2A. Public Hearing - Consideration of a request for a Request for Development Stage and Final Stage Planned Unit Development/Rezoning to Planned Unit Development for Phased Industrial Development including Industrial Service and Industrial Self-Storage as Principle Uses in the I-2 (Heavy Industrial) District.

<p>Prepared by: Gritman Consulting, Stephen Gritman, City Planner</p>	<p>Meeting Date: 03/04/2025</p>	<p>Council Date (pending Commission action): 03/24/2025</p>
<p>Additional Analysis by: Community Development Director, Community & Economic Development Coordinator, Chief Building Official, Assistant City Engineer</p>

Project Description: The applicant is seeing Development and Final Stage PUD and rezoning to PUD approval for a previously reviewed Industrial Services use. The Development Stage PUD for the Mastercraft development was approved by the City Council in July of 2024.

REV NO	DATE	DESCRIPTION
1	12/20/2024	REVISION PER CITY REVIEW
2	01/23/2025	TRASH ENCLOSURE & LANDSCAPE

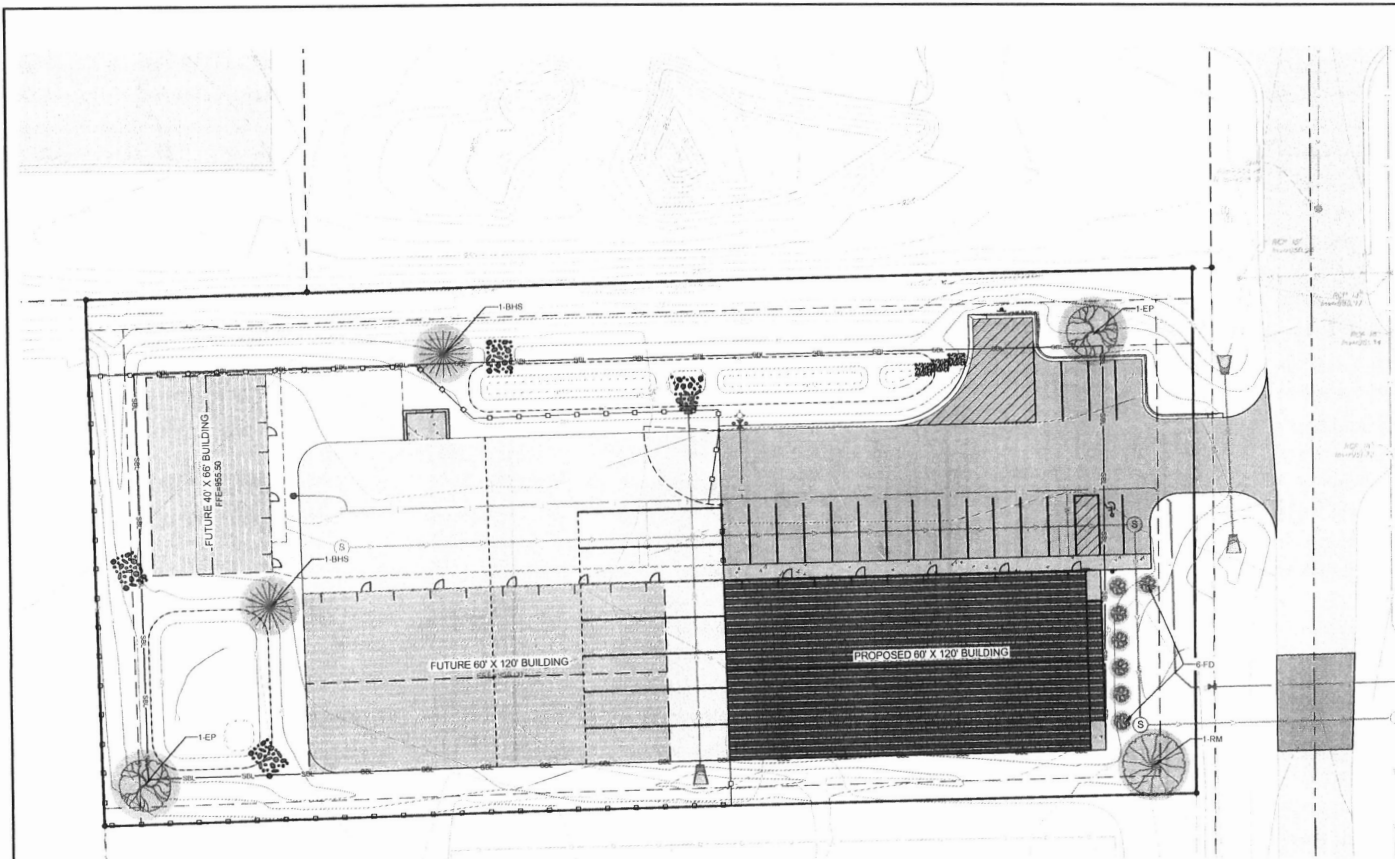
Site Planning. The site plan relies on a single access drive from Fallon Avenue. The driveway enters the site and serves parking on either side of the drive. This portion of the more “public” facing parking area would be paved and curbed per code. The driveway would then extend westward to the rear line of the building, after which the surface would transition to the crushed concrete requested by the applicant.

The plans illustrate a combination of uses in the rear yard area. There is a stormwater pond along the north property line, and another stormwater basin at the rear of the parcel. In northwest corner of the site, the applicant proposes a future storage building.

The central portion of the rear yard area is also crushed concrete and is shown on the applicant’s plans as circulation area that divides two more aspects of storage – one for general materials and equipment storage, and the other for truck and trailer storage/parking.

The I-2 zoning district requires that outdoor storage space cover an area no greater in extent than the floor area of the principal building. The applicant’s plans result in storage area that is up to 2.5 times the floor area of the proposed 7,200 square foot building. This aspect of the PUD is, with growth over time, suggested by the applicant to resolve itself, with the site plan illustrating additional building expansion over both the vehicle/storage area to the west, as well as in the northwest corner of the site. Further, it is noted that at least a portion of the space will be used for truck and equipment parking, rather than materials or general storage.

Parking. The site plan shows a total of 19 parking spaces along the north side of the building and drive aisle. As an industrial use of 7,200 square feet (or double that with expansion), site parking would only be required to total 9 spaces for each of the two main buildings. However, it is noted that the parking design on the site plan would result in several of the proposed spaces blocking access to overhead doors located along the north wall. For the overhead doors to be accessible, at least half of the proposed parking spaces would not be available, reducing the practical available parking supply to about 12 spaces on the property. As the current building requirement would be just nine spaces, the current plan can proceed as proposed. The second phase expansion may require additional review if additional parking is needed. The applicant is required to provide a site plan demonstrating the location for the additional stalls at the time of the second phase.

1. An updated site plan illustrating easements and adjusting first phase fenceline and landscaping, and future phase improvements is provided to eliminate potential conflicts with these easements as recommended by the City Engineer.

PAGE TITLE:
FRONT ELEVATION

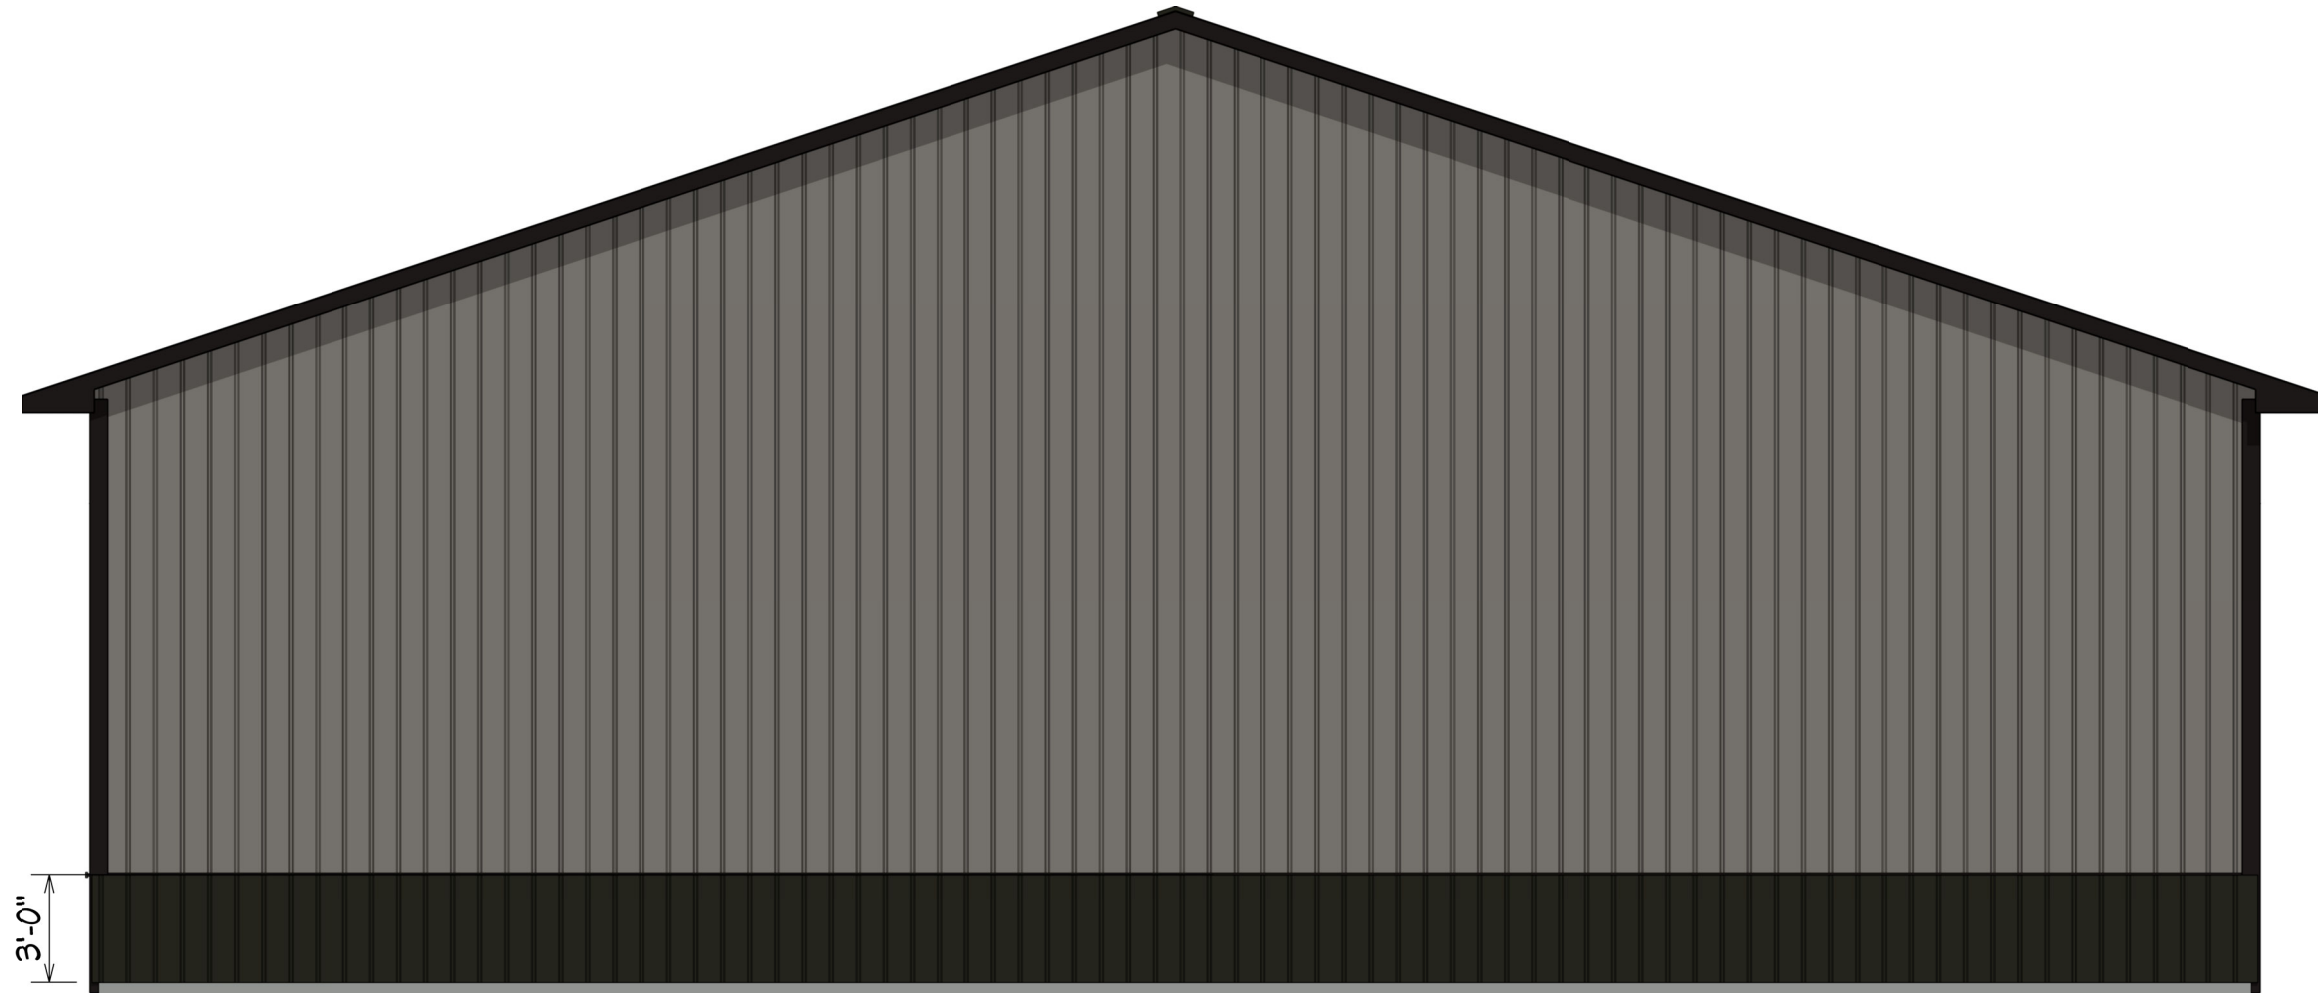
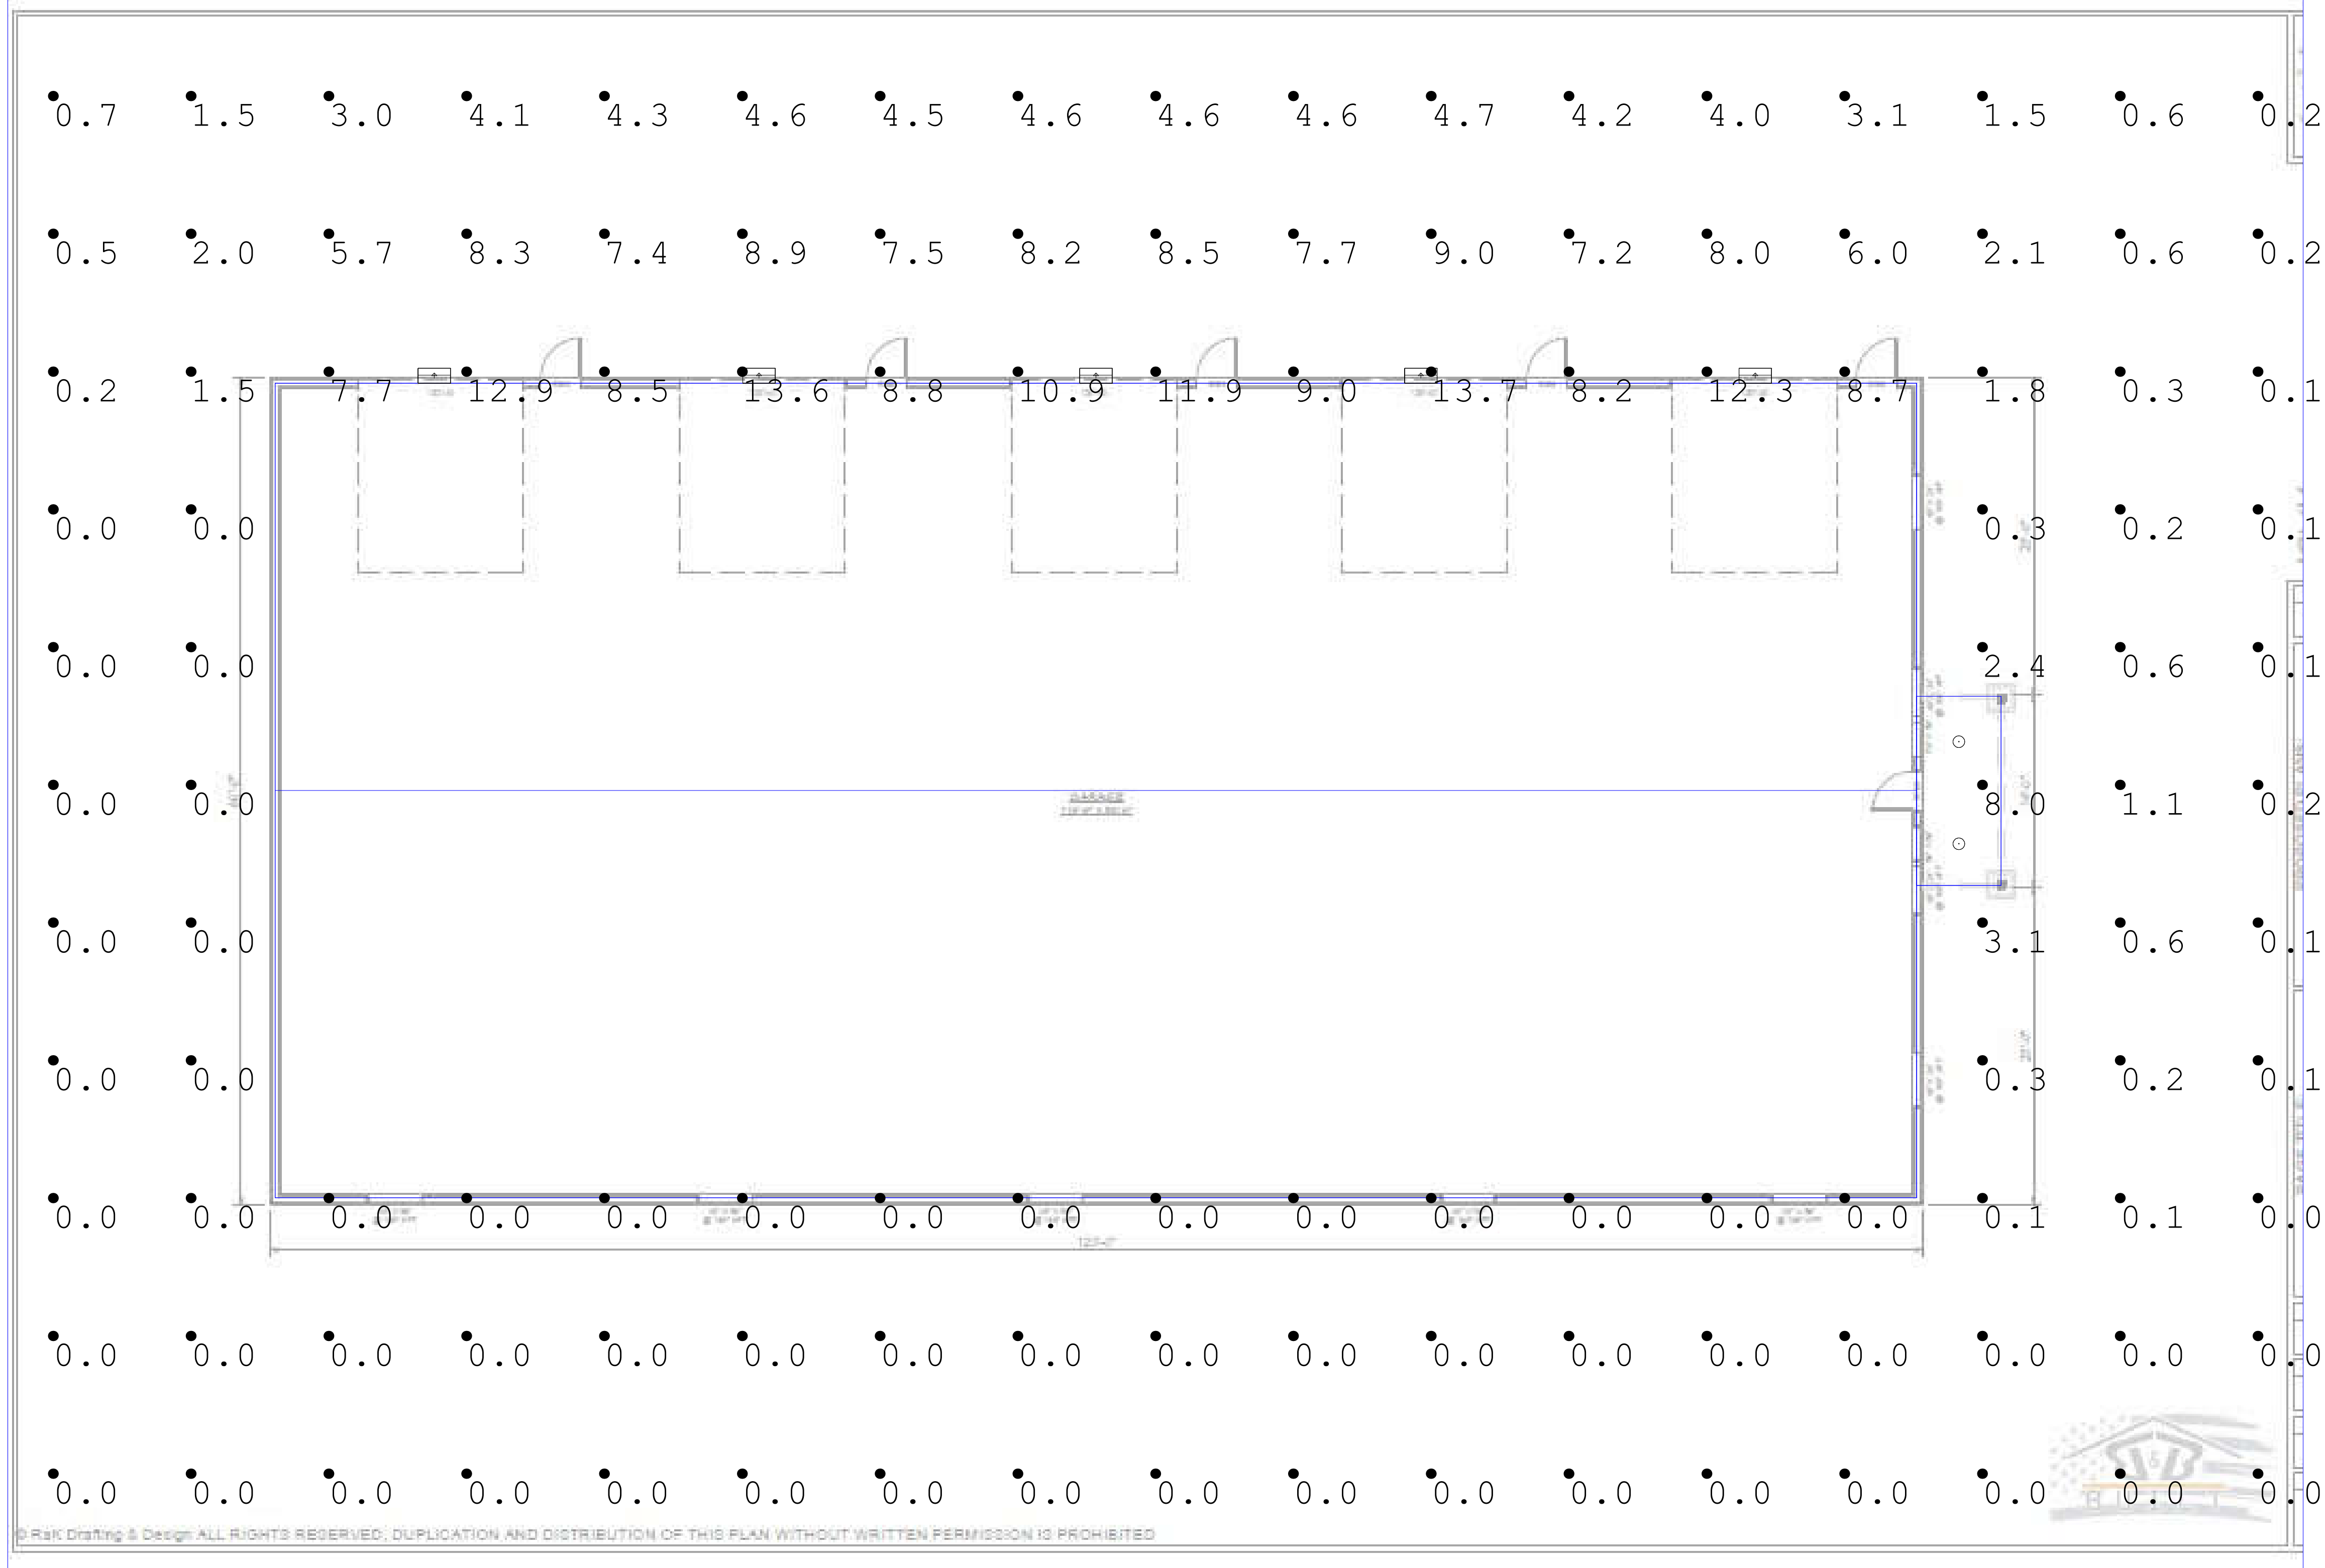
Building Design/Materials. Building materials for the structure are an aspect of departure from the zoning ordinance. Per code, building materials should be masonry on all sides, or a textured product to simulate masonry exterior materials. While the applicant has relied on other prior buildings constructed in the general area as examples, the City's revised materials code prohibits the exposed ribbed steel. Most recent permit approvals in industrial zones have relied on the updated code standards. The applicant is proposing to use steel siding, but with a textured surface. On the front elevation, the applicant proposes a wainscot of cultured stone.

As a condition of approval at the prior review, the City modified its approval to incorporate the requested textured steel siding (not ribbed panels) on all four sides of the building and including the masonry wainscot along the front (Fallon Avenue) face of the structure.

1. Accept the building materials proposed by the applicant to ensure that all four sides of the building are covered with materials that are composed of textured architectural steel, including the masonry wainscot finish on the front (Fallon Avenue) face of the structure.
2. The applicant's plans shall be revised to specify the material for trash enclosure, which shall be durable, maintenance free materials.
3. Specify in the Ordinance that upon construction of the second building, exterior storage-area surfacing will be upgraded to pavement capable of enduring the equipment used by the applicant on the site.
4. If developed in accordance with the layout and details of the current plan, the future phases may be reviewed and permitted with administrative approvals only.
5. No repair work is to be conducted outdoors.
